UNITED STATES PATENT AND TRADEMARK OFFICE

APPLICATION NO.	FILING DATE	FIRST NAMED INVENTOR	ATTORNEY DOCKET NO.	CONFIRMATION NO.
09/817,669	03/26/2001	George J. Hudak	10003916-1	9797

Office Action Summary

DETAILED ACTION

U.S. Patent Nov. 13, 1984 Sheet 2 of 2 4,482,246

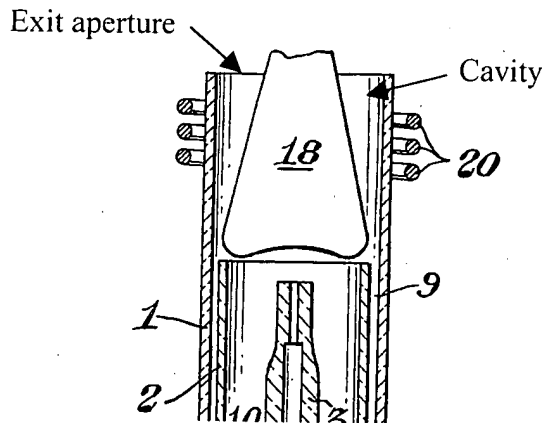
In regards to claims 1, 9, and 13, Meyer discloses in figure 2 and column 4 lines 34-43, an air-cooled gas discharge detector comprises a containing tube (1) that can be made from alumina, an air passageway (9) in contact with at least a portion of the outer surface of the gas

discharge tube, an entry aperture (8) for introducing air into the air passageway, an exit aperture (below) for allowing air to flow out of the air passageway, and an air source for supply a flow of air into the entry aperture for cooling the outer surface of the gas discharge tube.

Meyer is silent to the tube being made from sapphire.

In regards to claims 2-5, 12, 14-15, and 19-20, Meyer teaches all of the recited limitations of claims 1, 9, and 13 (above). Meyer further teaches in column 3 lines 3-10, that the discharge

(18) is powered by radio frequency source. Meyer further teaches in figure 2 that the radio frequency is introduced into a cavity (above), defined by an inner wall (3), two side walls (2) and an outer wall (1) and the air passageway extends alongside at least a portion of an exterior of the side walls.
